Subject: **Bid #: 8501-W6, Complete Streets Improvements – Endicott – Bigelow / DPW - CDBG**

**ADDENDUM NO. 5**

#### **Green Island Phase II Addendum No. 4: Questions and Clarifications**

# L124

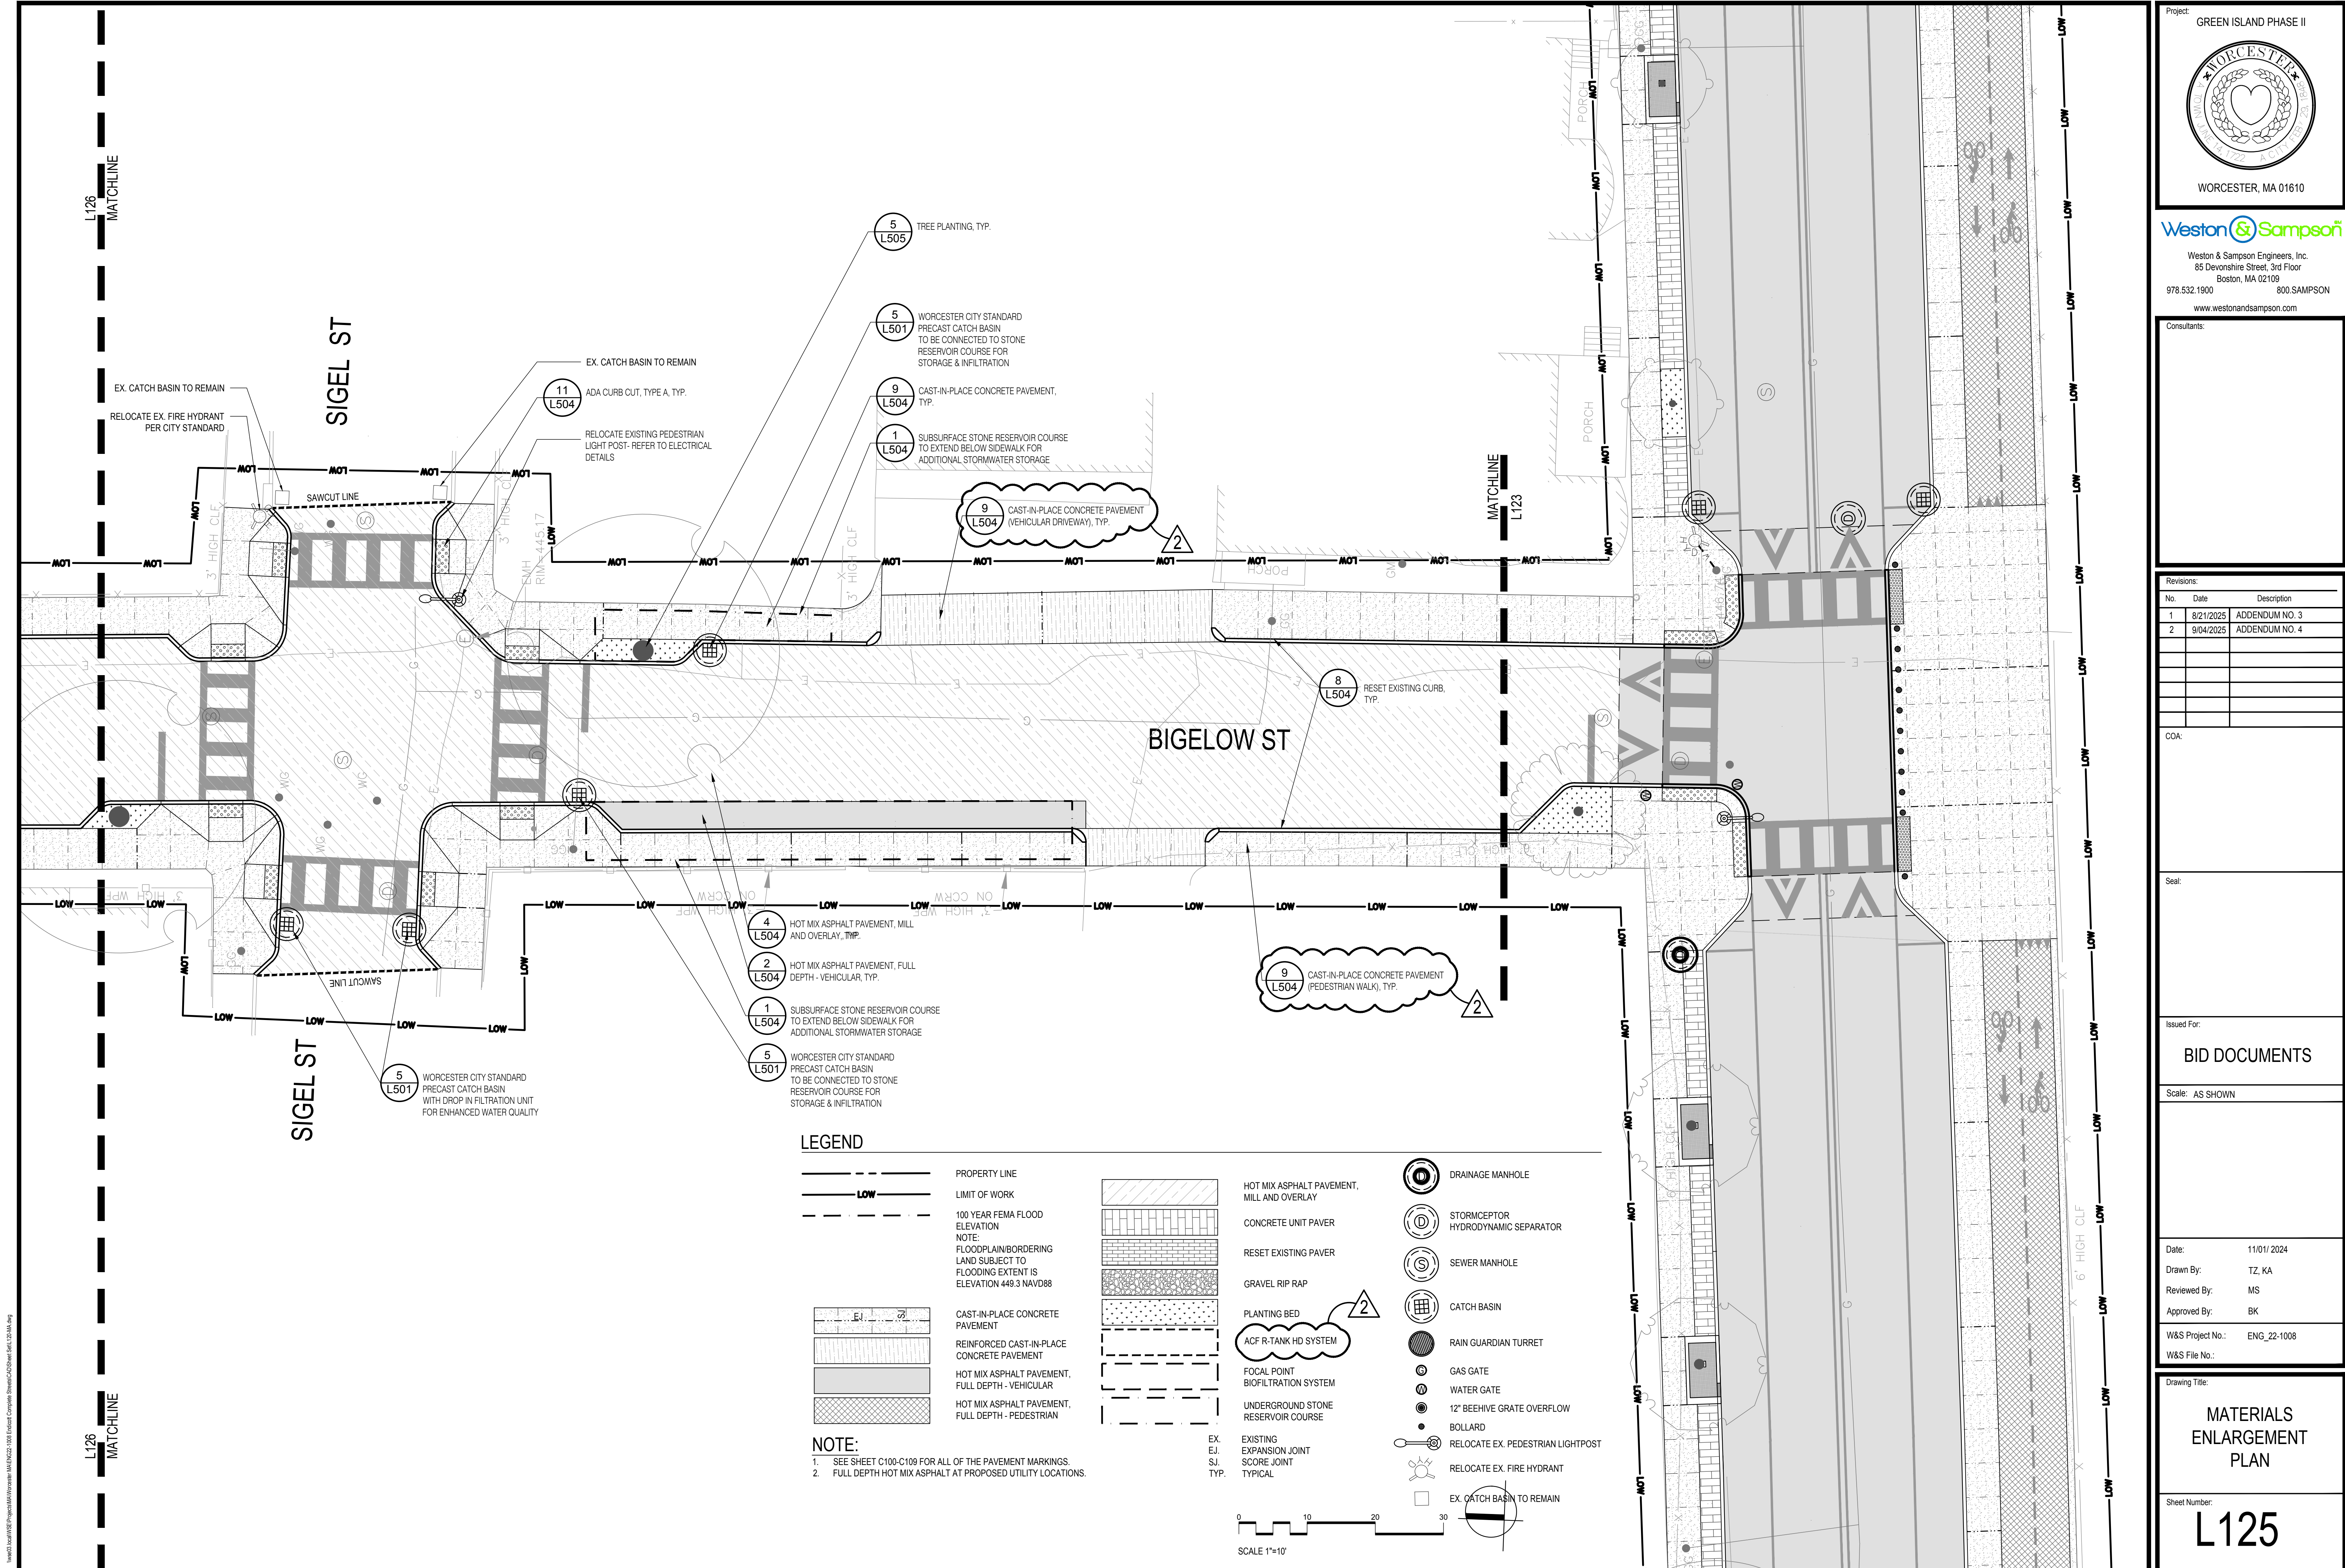
**Q: L124 calls to relocate existing sign and monument. Please provide specifications and details for the work.**

*A: Addendum 4 includes details for relocating existing sign and monument. Refer to sheets L504 and L505.*

L142

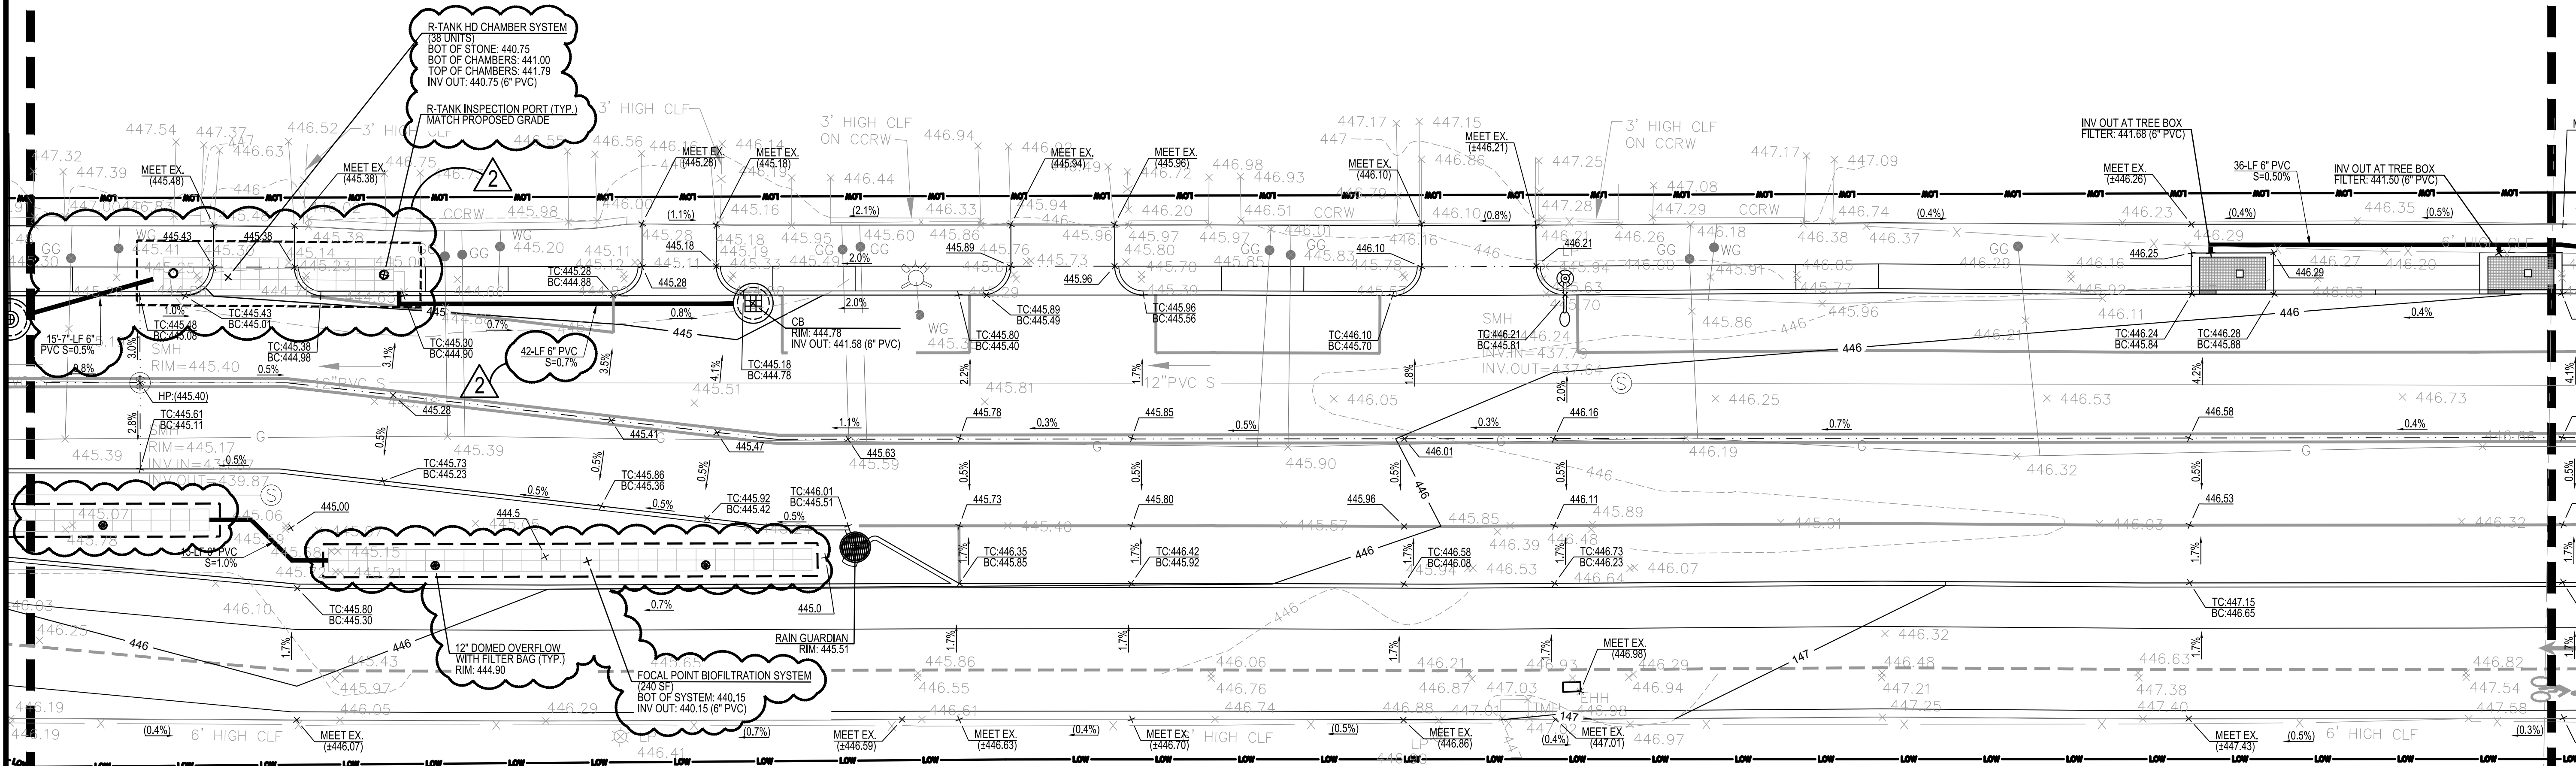
**Q: Please verify the quantity (4,600 cubic feet) of bid item #37 (R-Tank) is correct. We only see R-Tanks in two (2) locations (plan sheet L121 & L122). Also, please verify that the height of these R-Tanks is only 9.4" as shown on Detail 1 on plan sheet L502.**

*A: Please refer to sheets L141 and L142 Grading Enlargement Plan for clarifications.*
